PUBLIC IMPROVEMENT PLAN NARRATIVE

STAFFORD LOGISTICS CENTER

Prepared: December 14, 2018
Revised: March 1, 2019
Revised: April 19, 2019
Revised: June 21, 2019
Revised: July 10, 2019
Revised: September 26, 2019
Revised: April 6, 2020
Revised: May 8, 2020
Revised: Aug 27, 2020 - 1st Amendment
Revised: Oct 26, 2020 - 1st Amendment
Revised: Dec 21, 2020 – 1st Amendment
Revised: Feb 22, 2021 – 1st Amendment
Revised: April 5, 2021 – 1st Amendment
Revised: June 22nd, 2023 2nd Amendment
WM: DCS18-4121
WM: DCS20-4039
WM: DCS23-4005

STAFFORD LOGISTICS CENTER FRAMEWORK DEVELOPMENT PLAN (FDP)

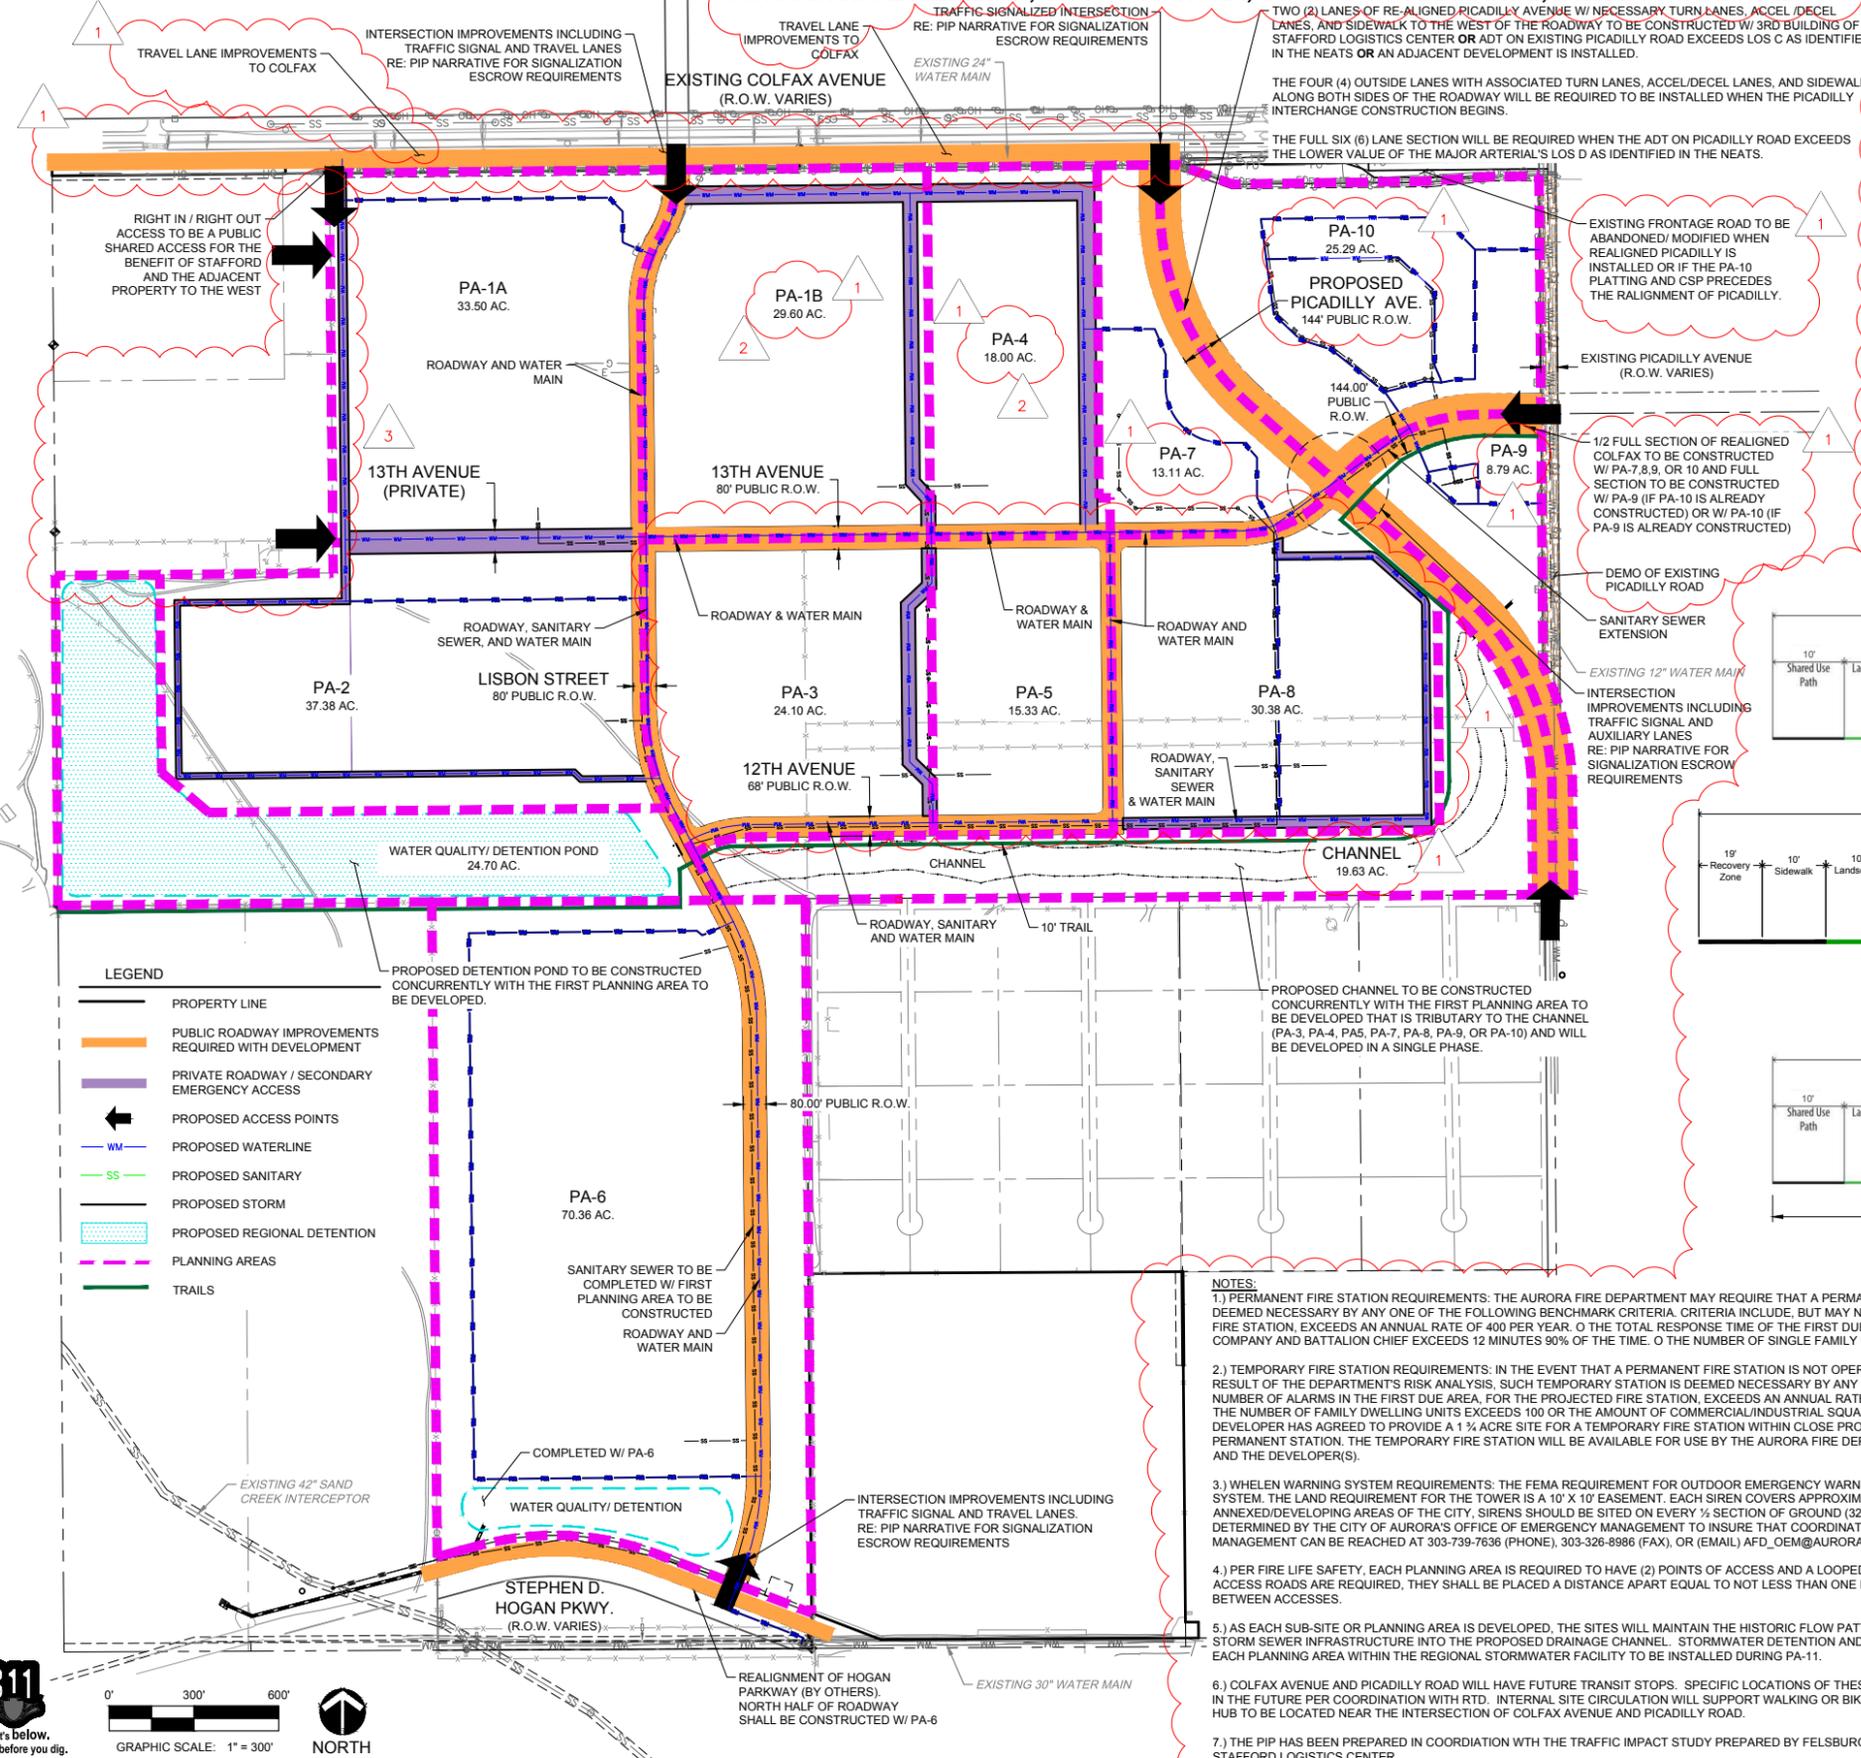
- AMENDMENTS**
- PLANNING AREAS 3, 5, & 8 HAVE BEEN MERGED INTO ONE PLANNING AREA (PA-3). 13TH AVENUE REVIS FOR NEW BUILDING ALIGNMENT. CLOUDED PA'S HAVE ADJUSTED REVISED. TITLE AT TOP OF PAGE ADJUSTED PER COMMENTS.
 - PLANNING AREAS 1B & 4 HAVE CHANGED IN SIZE.
 - PLANNING AREA 11 TRAILER LOT HAS BEEN ADDED.

PUBLIC IMPROVEMENT PLAN (PIP)

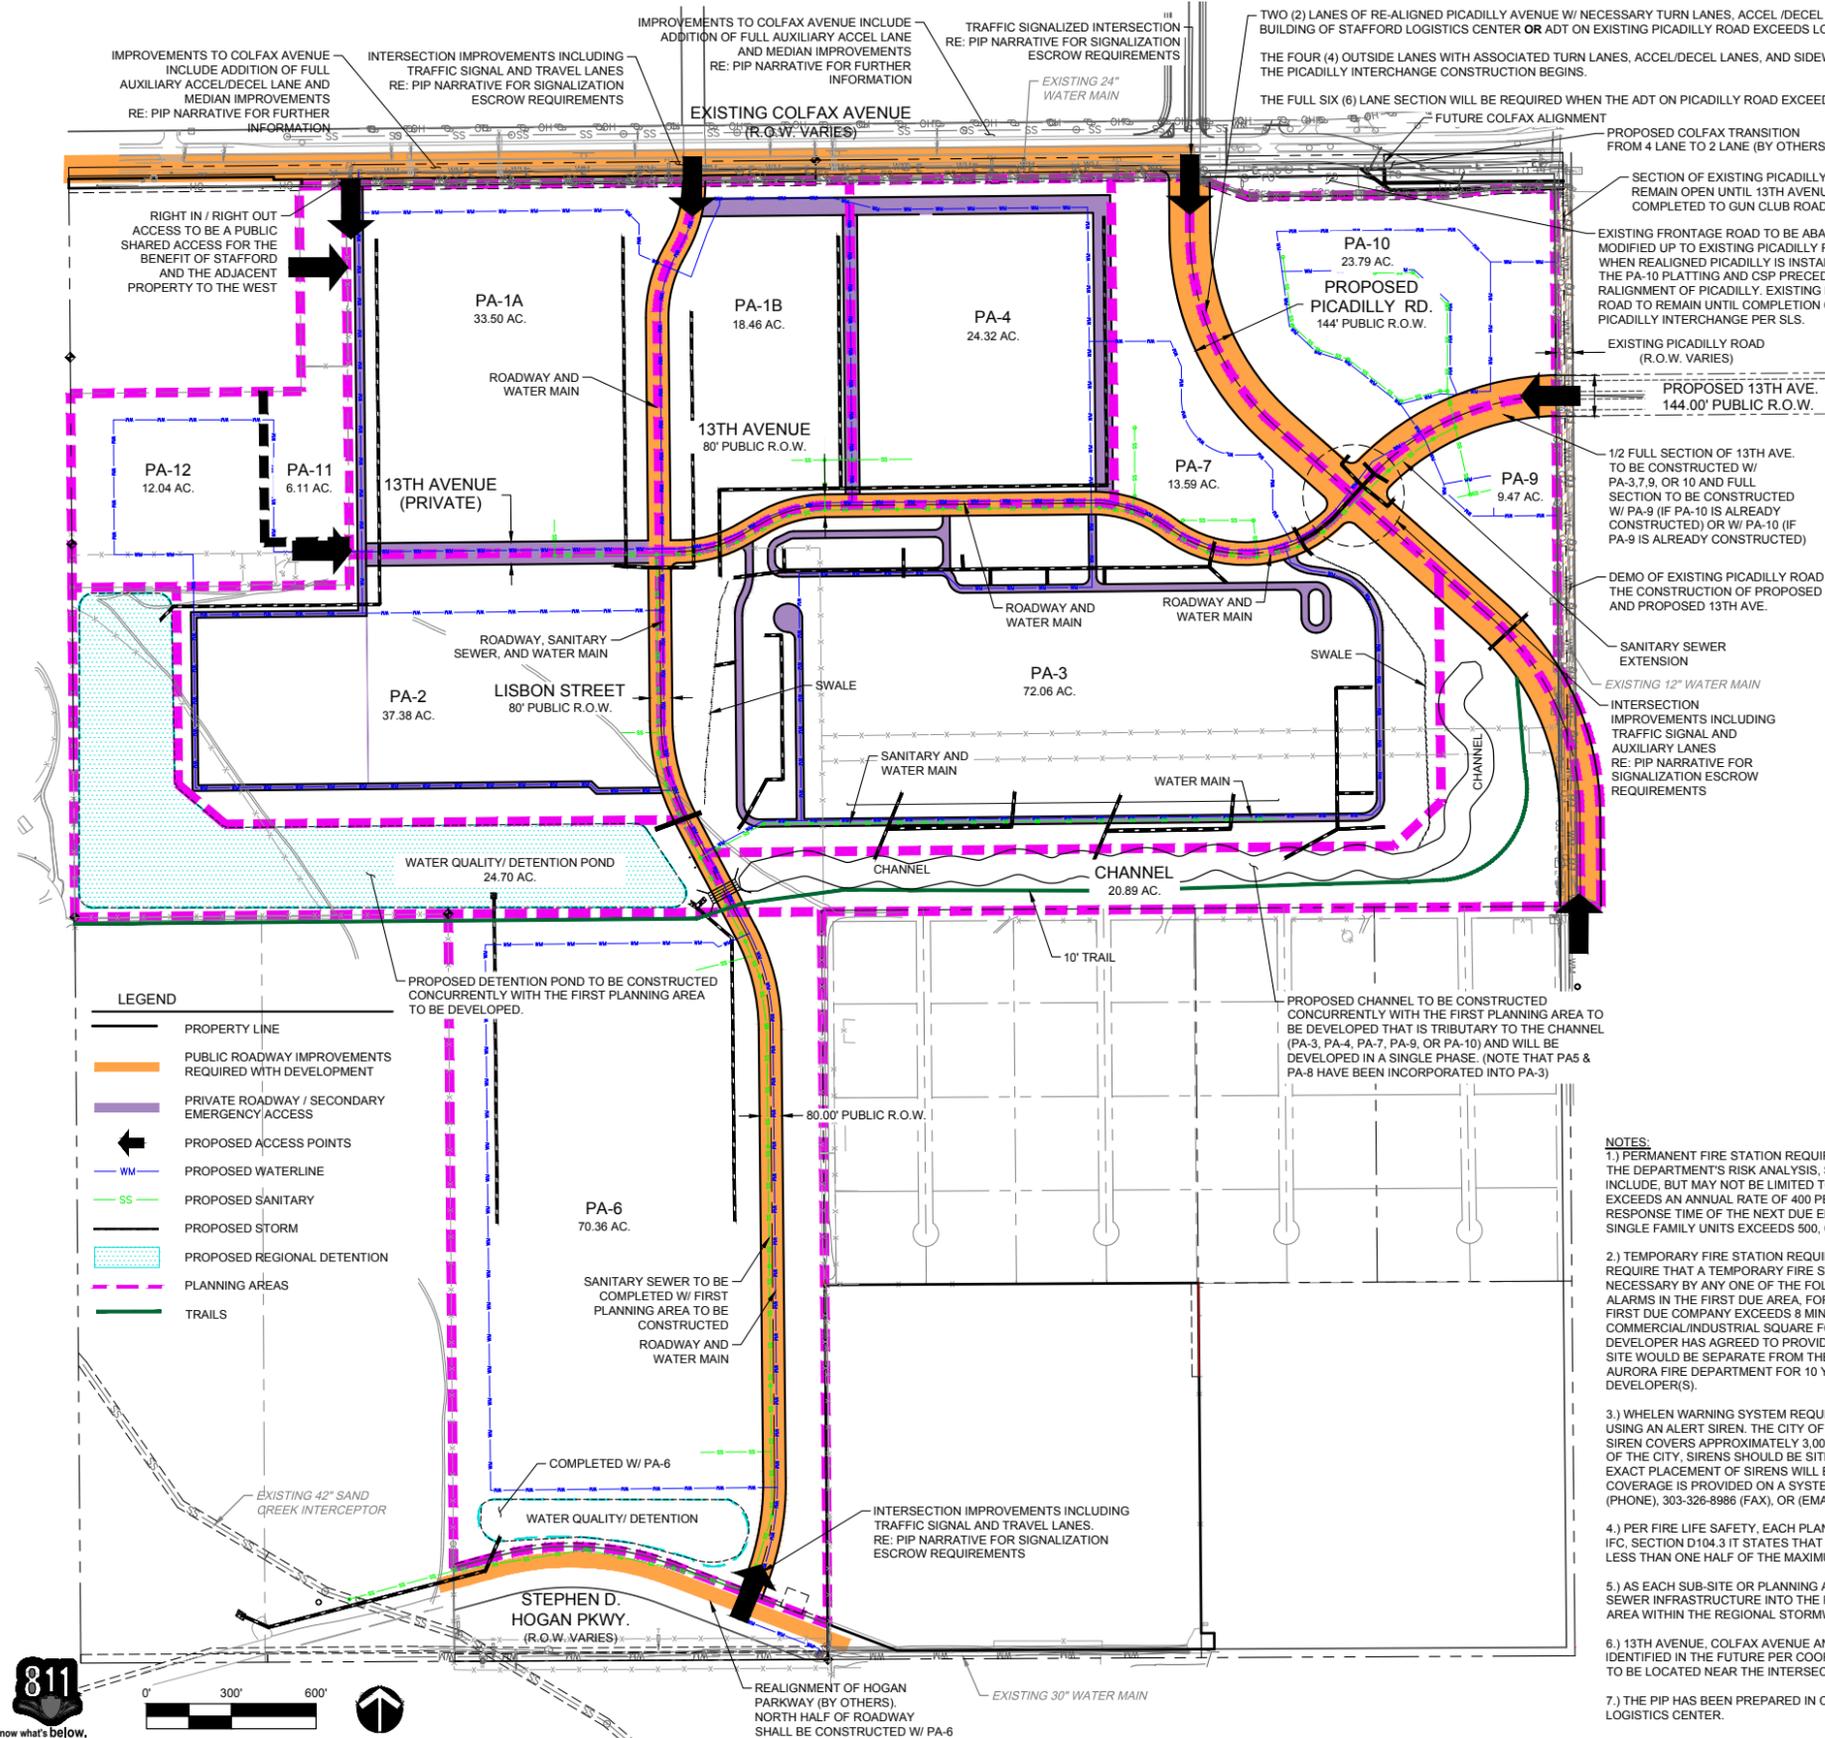
- 8) PA-5 AND PA-8 HAVE BEEN REMOVED AND INCORPORATED INTO PA-3.
